**J-3 Comments on the Draft EA
and FAA Responses**

Comments and Responses Volume 2

RE: Comments on the FAA’s South-Central Florida Metroplex Draft Environmental Assessment

FLL Comments - FAA South-Central Florida Metroplex Draft EA - July 23, 2020

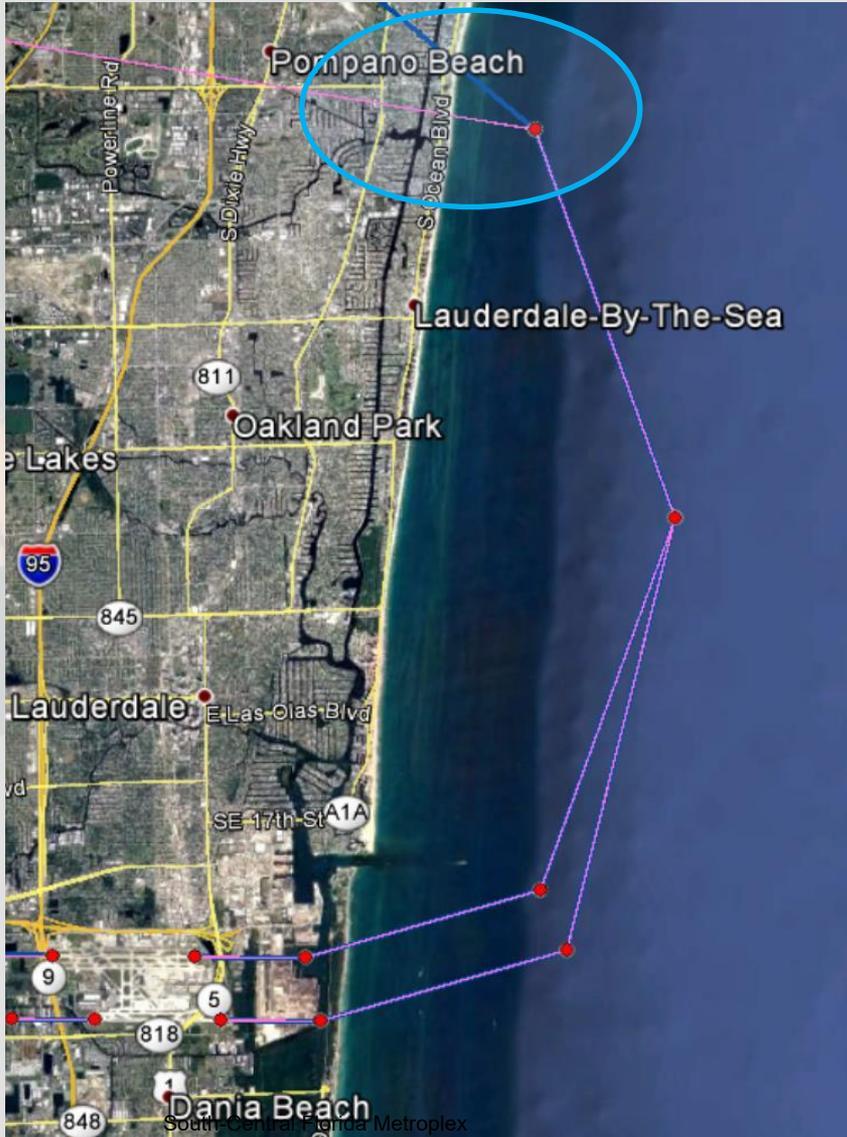
LLBOW and LLEGG are flyby waypoints with a 080 heading. Changing them to flyover waypoints or a shift further south would help keep aircraft south of the Harbor Isles communities during climb out.

Noise complaints are currently generated where aircraft transition from water back over the coast in the Pompano Beach area. Concentration of overflights has the potential to increase community concerns. Consider using RNAV vector or open RNAV procedures to increase dispersion.
